**RE: Clifton Ave & William St Development
Grading & Drainage Plan
Engineer's Stamp Date: 03/09/22
Hydrology File: L14D064**

Based upon the information provided in your submittal received 03/09/2022, the Grading and Drainage Plan is approved for Grading Permit, and for action by the DRB on Preliminary Plat.

**OVERALL
GRADING &
DRAINAGE
PLAN**

SHEET NUMBER
CG-100

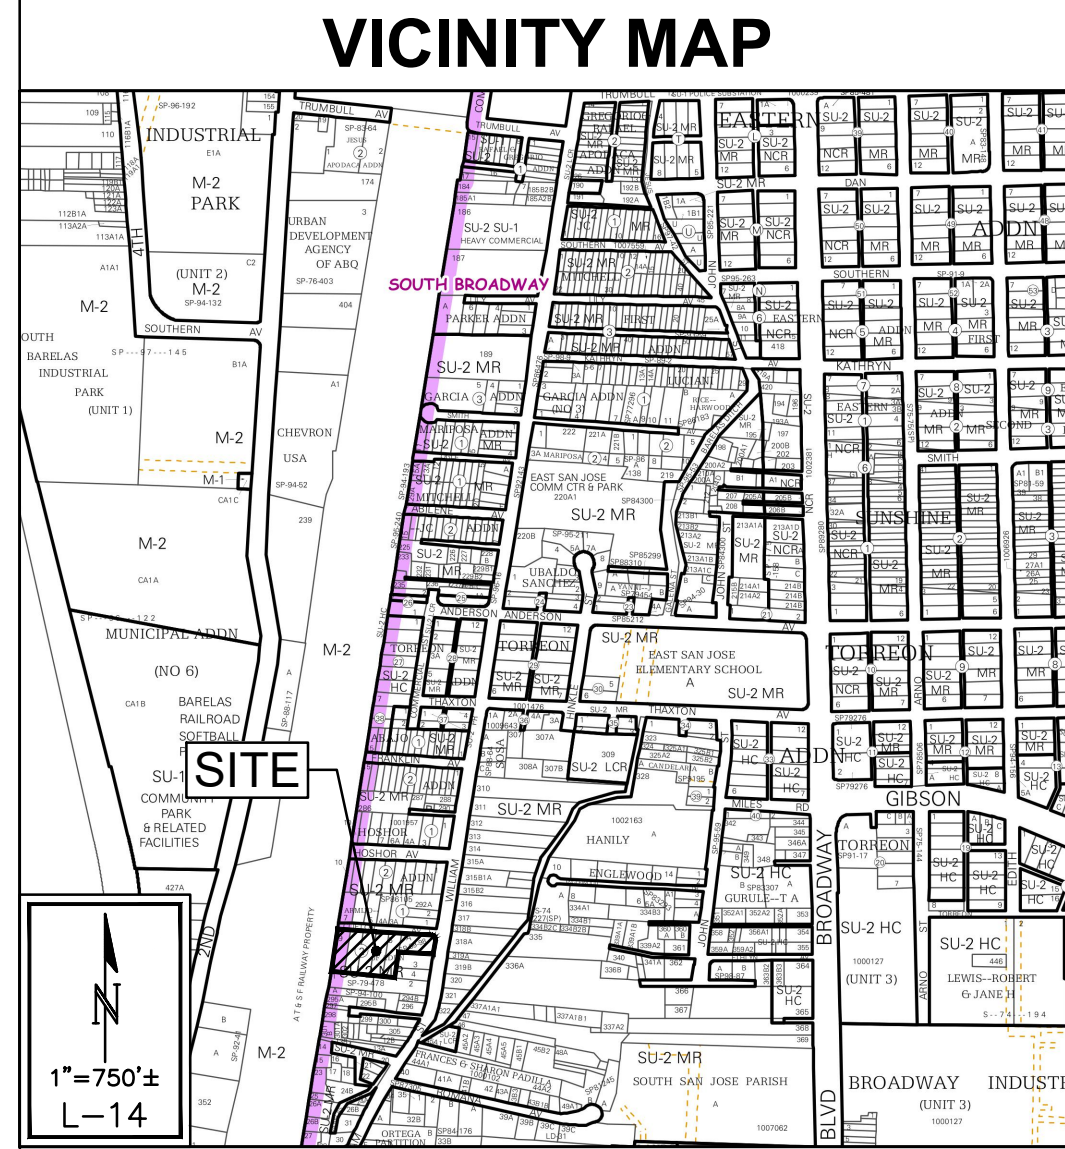
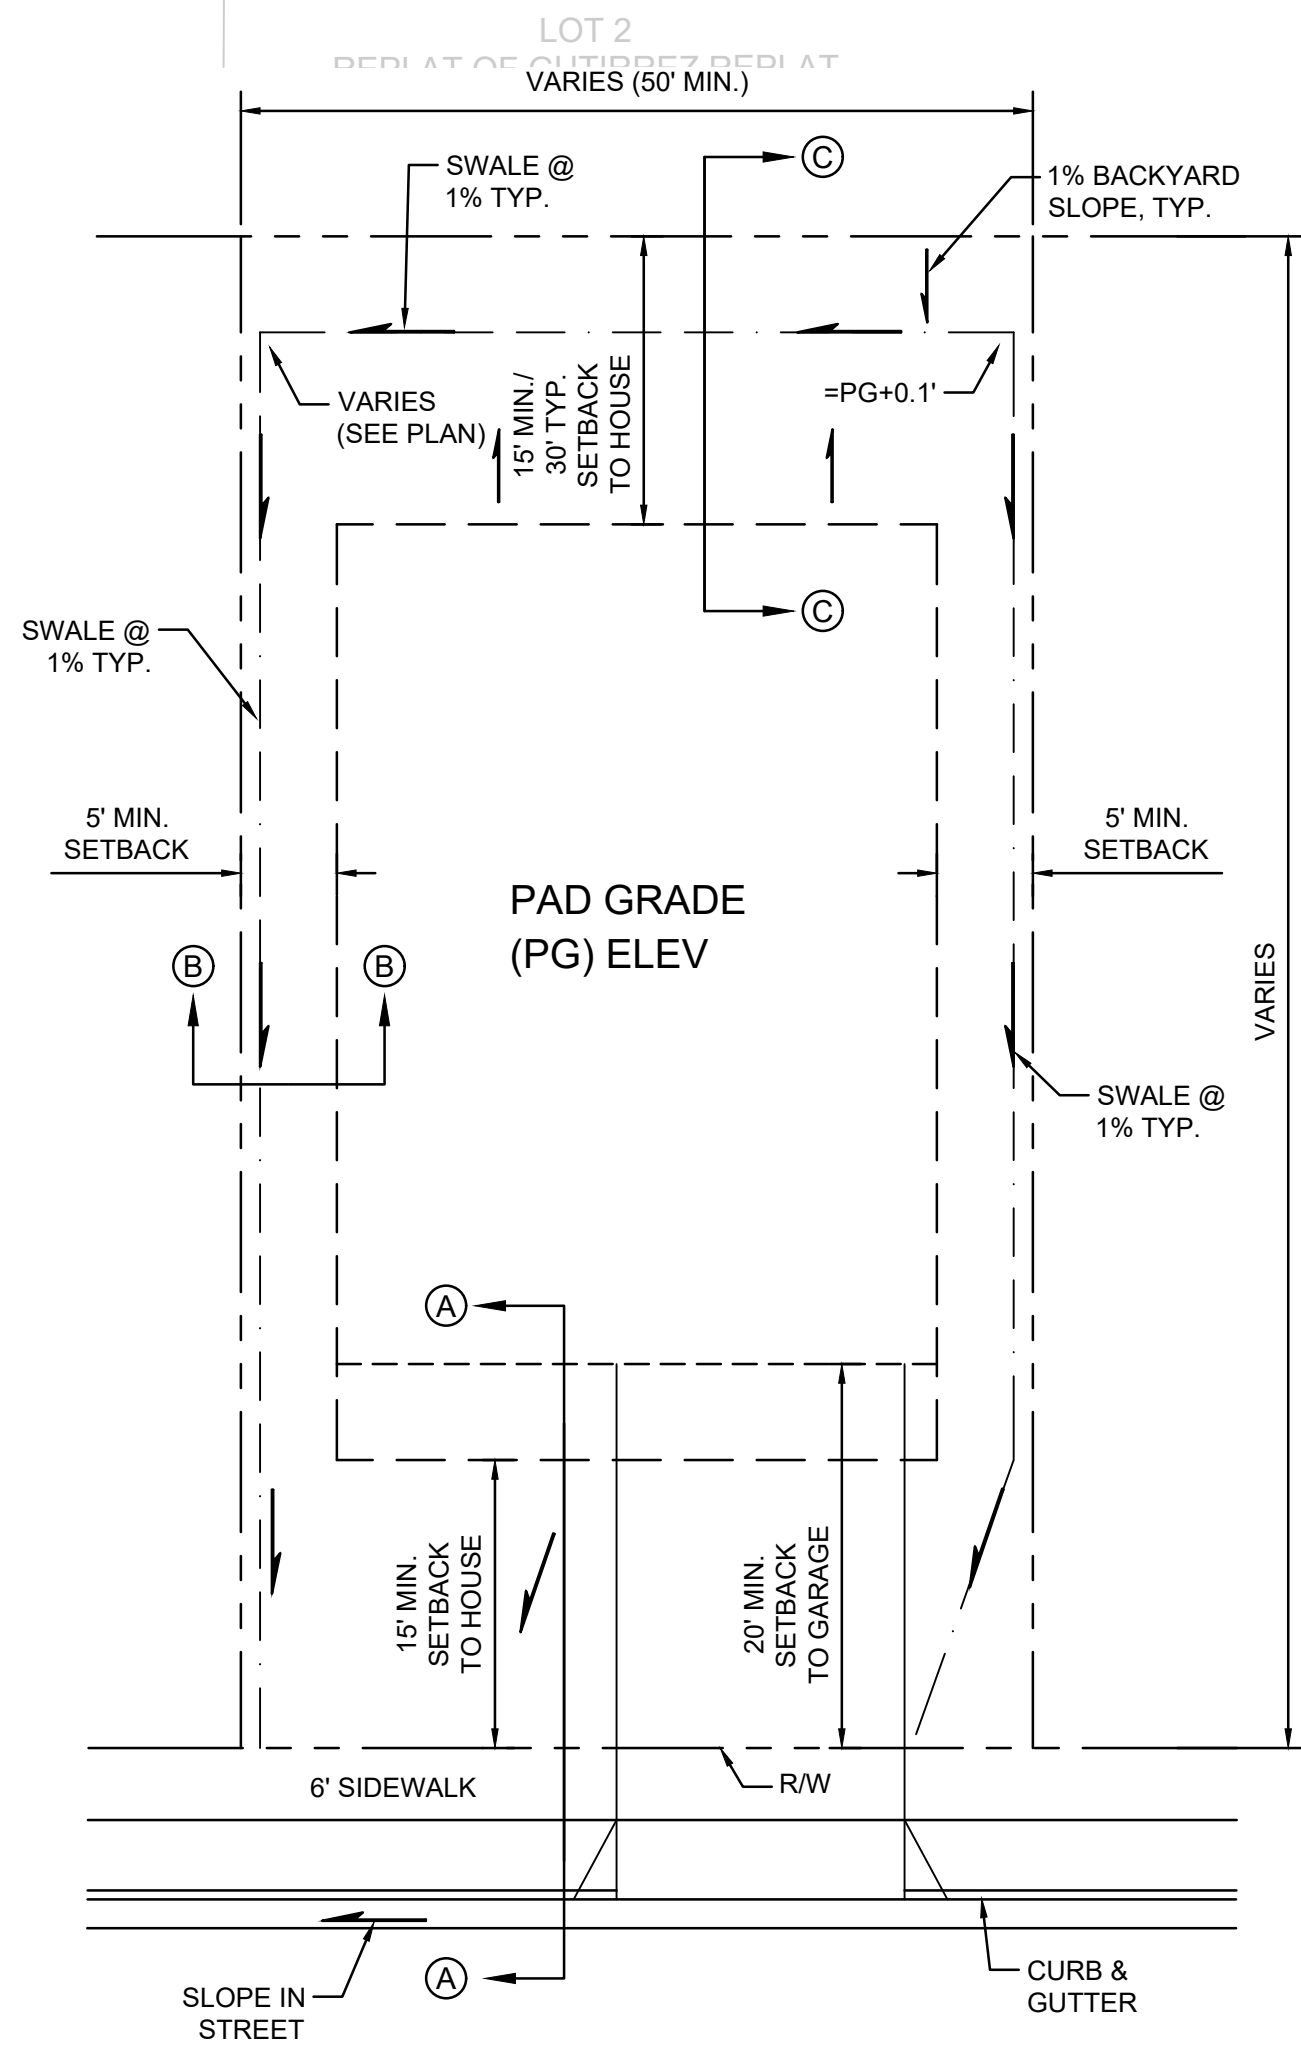
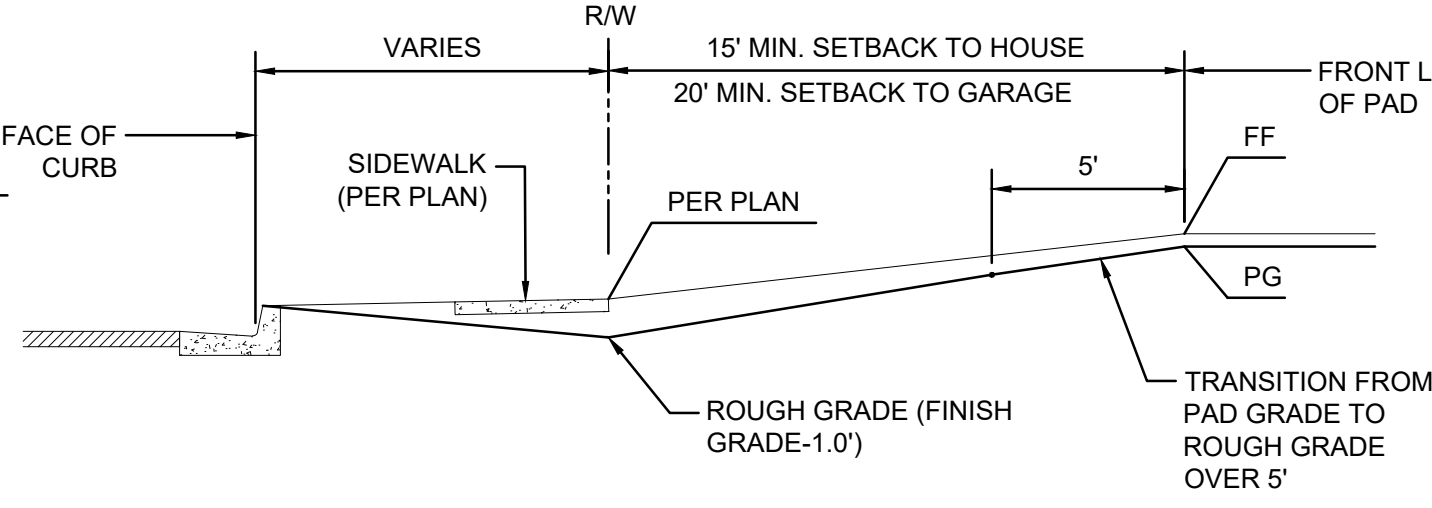
1. Pad Certification. Once lots are properly graded, a pad certification will be required for approval.

2. Building Permits. Building permits for each lot can be obtained once the Pad Certification is approved by Hydrology.
